ADDENDUM #3

RE: RFP 21/27 CPS Nature School

TO BIDDING DOCUMENTS ENTITLED:
Columbia Public Schools
RFP 21/27 CPS Nature School

PWA PROJECT NUMBER: 201621.54
PWA PROJECT NAME: CPS NATURE SCHOOL COUNCIL HOUSE

DRAWING NO.
A101
 Sheet 1 of 3

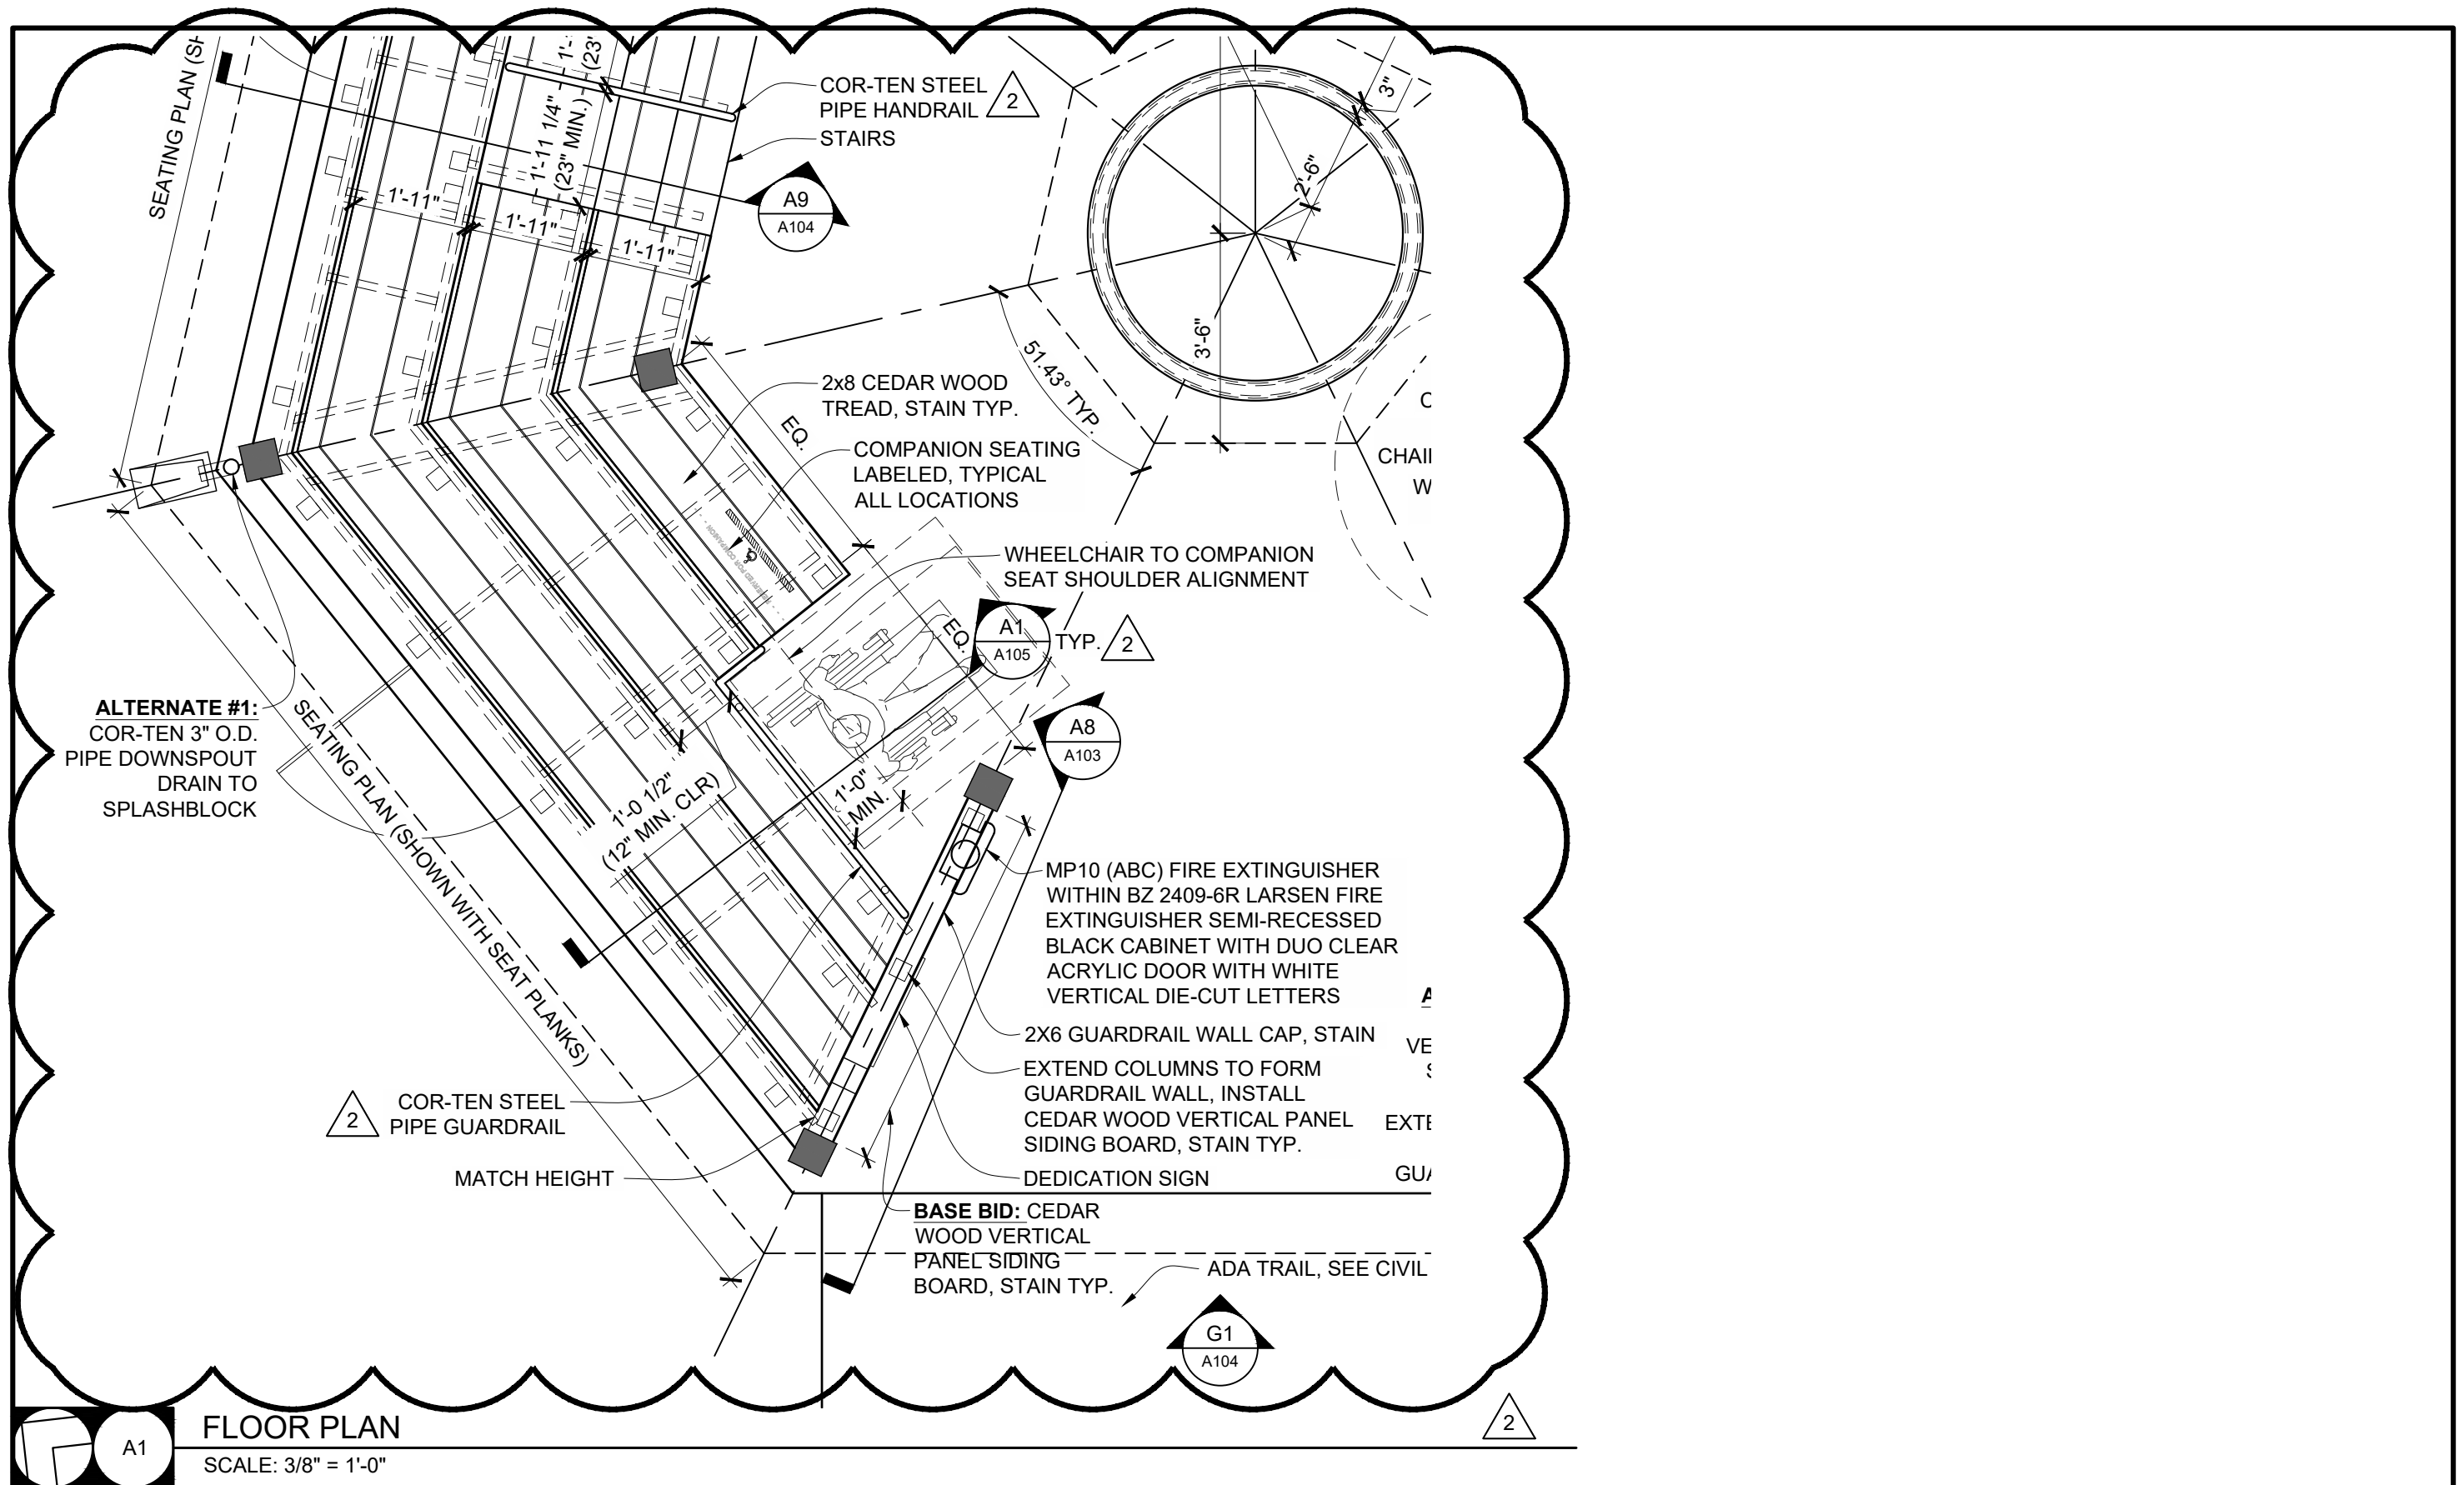
- d. **Q: On drawing A101, there might to be a railing behind the three wheel chair spaces to prevent a seated person from falling into the wheel chair space below but there are no notes or sections/elevations to show if there is any railing or barrier. The question is; Is there a railing or barrier behind the wheel chair space? And if so, what does it look like?**

- h. **Q: A104 shows the handrails to be Cor-ten steel but A101 calls for them to be galvanized steel. Please confirm which is correct.**

1. **Clarification, Detail A1 on Sheet A-101 – Plans & Details:**

New section detail mark has been added to the drawings to show the guardrail between the wheelchair space and the bleachers behind. Also clarifies the handrail material shall be Cor-ten steel.

A: Yes, a Cor-ten guardrail shall be installed between the wheelchair space and the seated benches behind, typical all locations. This guardrail is shown in G1/A104 in elevation. Floor plan on sheet A101 has been updated to show an additional section detail at the guardrail. A section (A1 on sheet A105) has been added showing a section cut between the benches and the wheelchair space showing the guardrail. Please see the attached new detail A1/A105.

A: Handrails shall be Cor-ten. A101 has been revised to state Cor-ten. Please see attached revised plan detail A101.

EAVE DETAIL

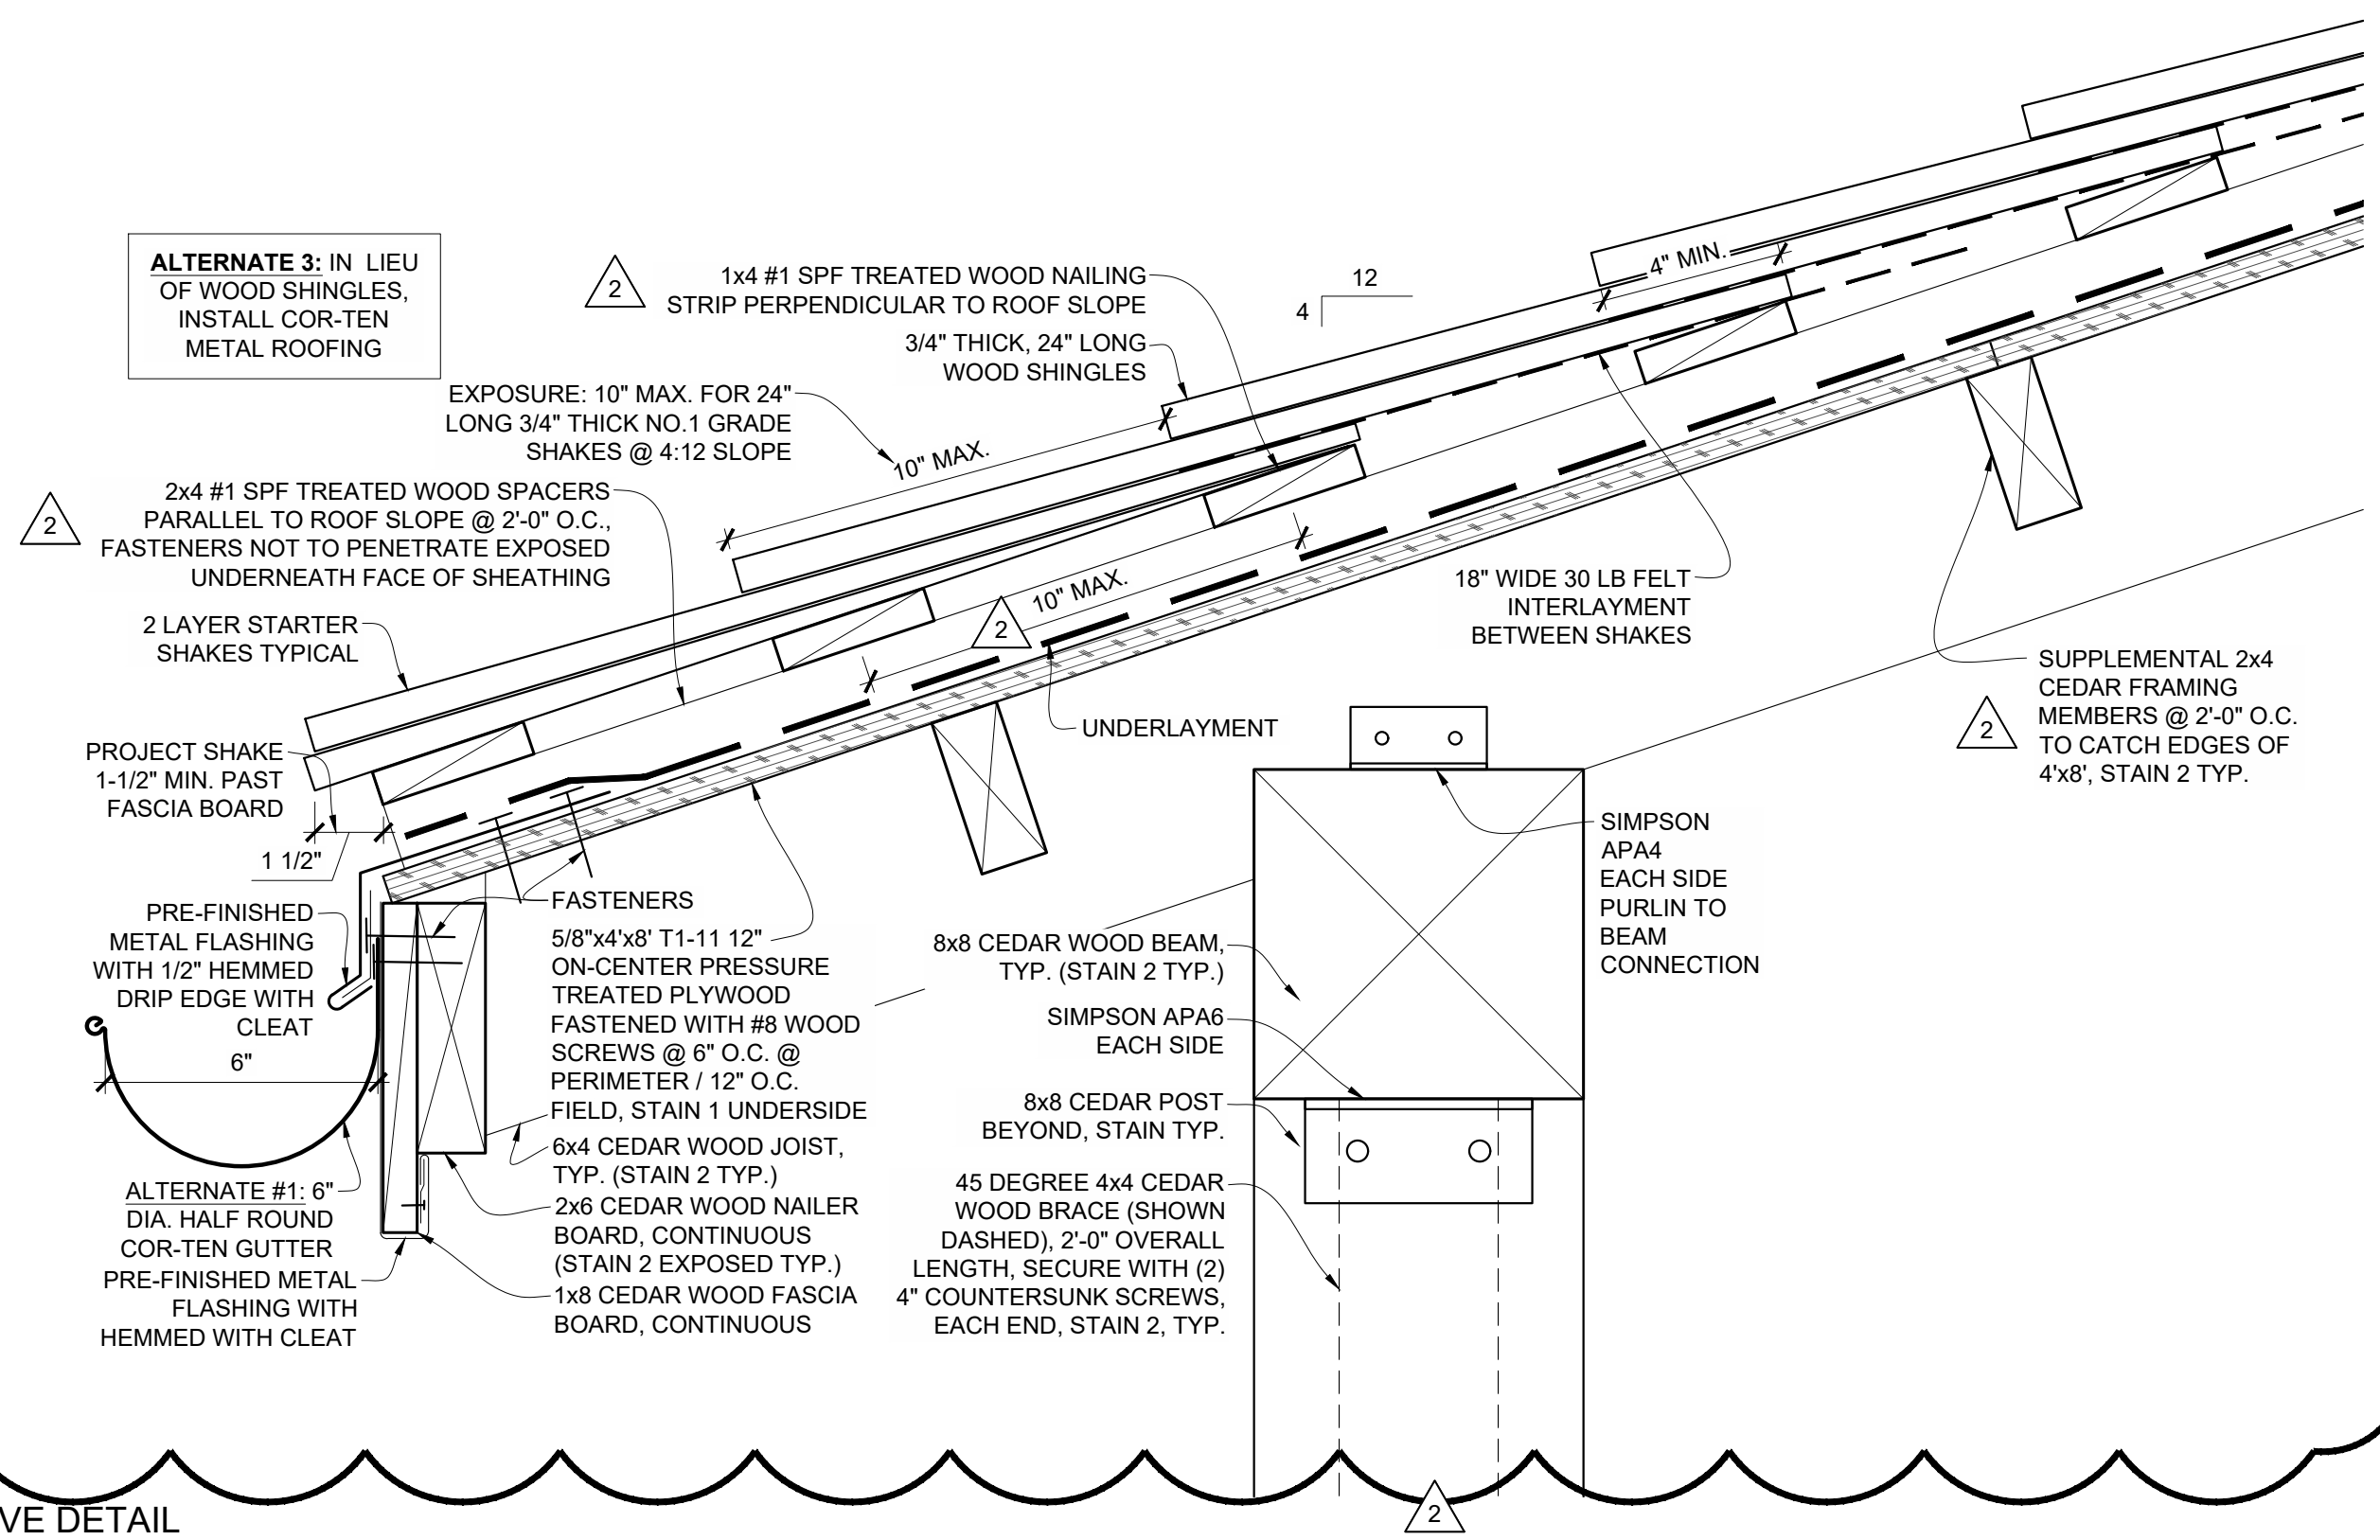
- a. **Q: On the roof section H8-A103 the question is at the end of the rafter tail I need a clarification as how it is finished is it enclosed and will the material be smooth cedar like the rest of the building. Or will it be #2 Spf and will the 2x4 framing mirror what is below it or run the same direction as the 4x6 below 2' on center with a 3/4" cedar for the skip sheathing or a #2 1x4 pine. That also leaves an area approximately 4' x 4' that is supported by 2x4 flat with 1x4 skip sheathing.**

- f. **Q: The 1x4 for under the wood shakes on sheet A103 does not list the species of wood that is required.**

2. **Clarification, Detail H8 on Sheet A-103 – Sections:**

Material & spacing has been added or revised for the 1x4 and 2x4 framing above the sheathing and the 2x4 framing below the sheathing.

A: Detail H8 on sheet A103 has been revised to call out a material (#1 SPF treated) and spacing (2'-0" o.c.) for the 2x4 wood spacers parallel to the roof slope above the roof sheathing.

A material (#1 SPF treated) has also been called out for the 1x4s at 10" o.c. installed over the 2x4 wood spacers.

This revised detail also clarifies the material (cedar) for the 2x4 supplemental framing members installed below the sheathing. The spacing for the supplemental 2x4 framing members installed below the roof sheathing shall be revised to 2'-0" o.c. typical from the previous 4'-0" o.c.

The 1x4 and 2x4 support framing below the cedar shakes will be exposed at the eave, as shown in detail H8 on sheet A103. This will allow air flow under the cedar shakes to allow them to dry out. A pre-finished metal flashing with a hemmed drip edge will cover the sheathing and fascia below as per detail H8 on sheet A103.

A: The 1x4 for under the wood shakes and the 2x4 wood spacers parallel to the roof slope shall both be #1 SPF treated.
